MEMORANDUM

TO: Architectural Review Board
FROM: Khris Taggart, Sr. Planner I
RE: ARB2024-71/SP2024-25 400 Rio Rd. W Concept Plan Revisions
DATE: March 3, 2025

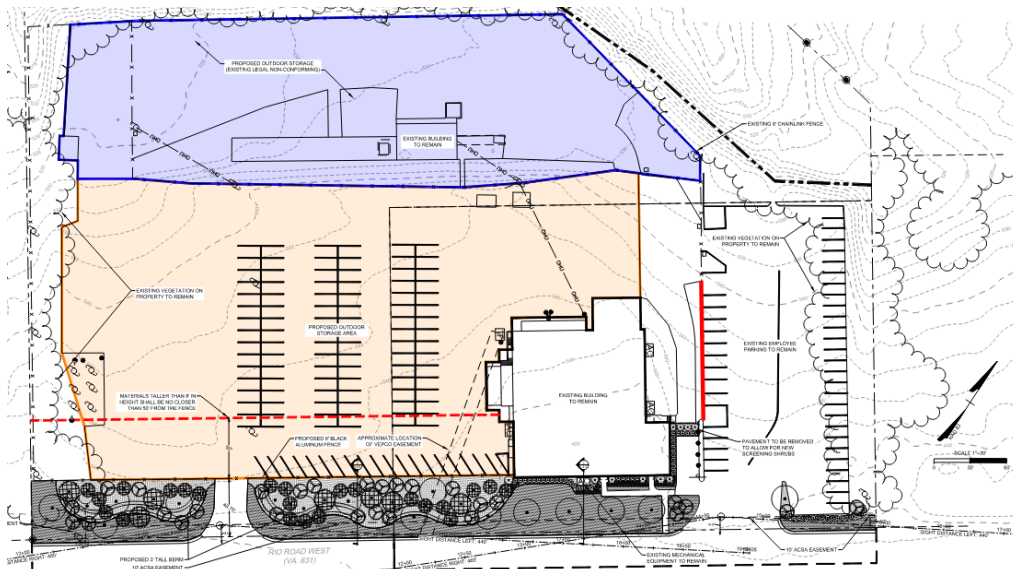
4. The Zoning Division has indicated that the non-conforming storage area should be brought into conformity with this proposal. This might be accomplished with appropriate fencing and additional planting east of the building. A rendering showing this area from the street would be helpful.

- The revised concept plan shows pavement east of the building closest to the frontage being removed to accommodate screening shrubs and shrubs being added to the frontage planting area east of the entrance to the employee parking lot. This landscaping is expected to reduce visibility of the non-conforming storage area; however, the storage area will still be visible from the EC from the employee parking entrance when vehicles are not parked in that lot. Revising the plan to show screening shrubs along the fence line between the building and the employee parking lot (highlighted in red below) could help further reduce the visibility from the EC of the non-conforming storage area.
